Monthly Specification Update

Intel® Server Board S3420GP

Intel Order Number E82362-006

March 2011

21. Intel® Matrix Storage Manager of Intel® Rapid Storage Technology (Intel® RST) may show HDD incompatible status under certain conditions

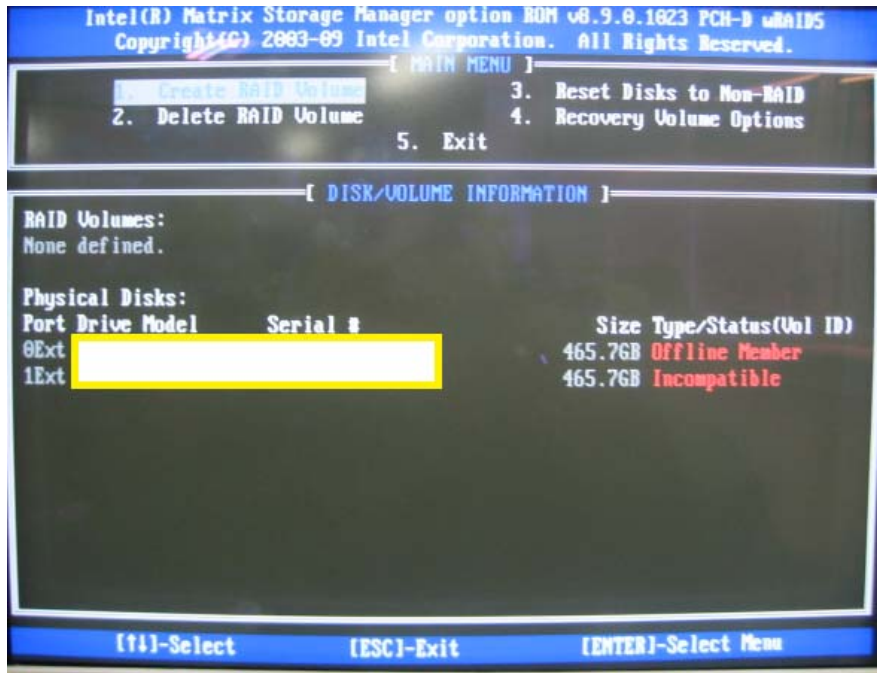
Problem	Under RAID 1 mode, if the operating system does reboot after one HDD is unplugged, the other HDD will show incompatible status even after the other HDD is plugged in again.
Implication	Please refer to the picture below.

Status This issue was fixed in BIOS version 0048.

Workaround Downgrade BIOS to version 0042 when the issue is happening
